Re Ace Apartments Proposal, 4602 Cottage Grove Road

To the Urban Design Commissioners:

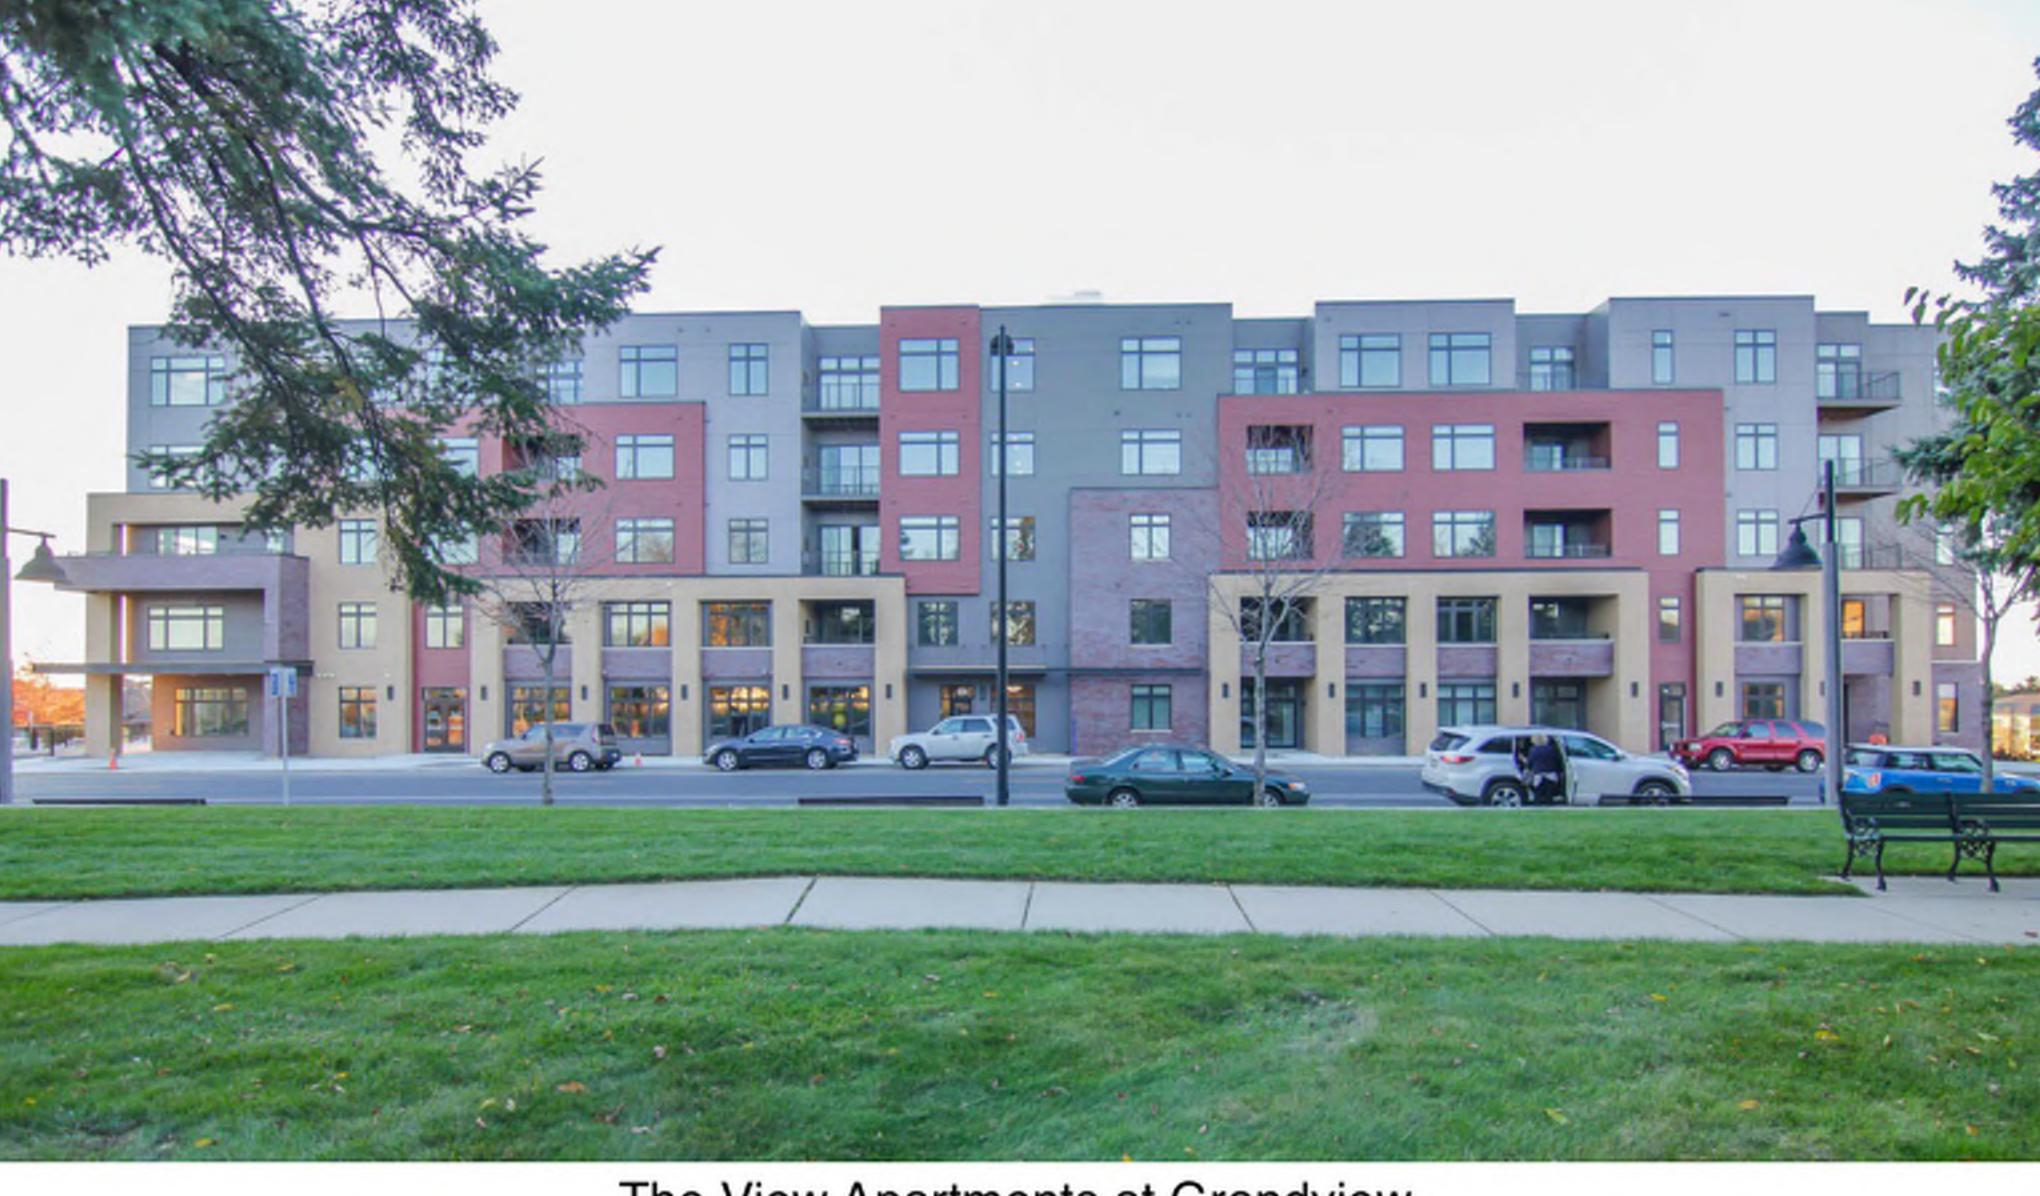
Cottage Grove Road has a surfeit of orange/rust-colored architectural elements in new construction along or near the corridor and does not need another. Please see attached photos of Pinney Lane Apartments at 902 Royster Oaks Drive; Royster Commons Apartments and new Pinney Library 523 Grand Oak Trail/516 Cottage Grove Road; and The View Apartments at Grandview, 818 North Star Drive. Continuing to propagate the use of this strong color in new designs along the street will not bode well when this color patterning falls out of favor as it will.

Also attached are two examples of apartment buildings that offer a restrained palette: Stone House Development's The Overlook at Midtown at 8119 Mayo Drive and Rouse's Olbrich by the Lake Apartments at 3528 Atwood Avenue. While the architectural design of Olbrich by the Lake is a vital part of its appeal and cannot be replicated on the Sentry site, its use of a restrained palette has allowed the almost 25 year old property to successfully age.
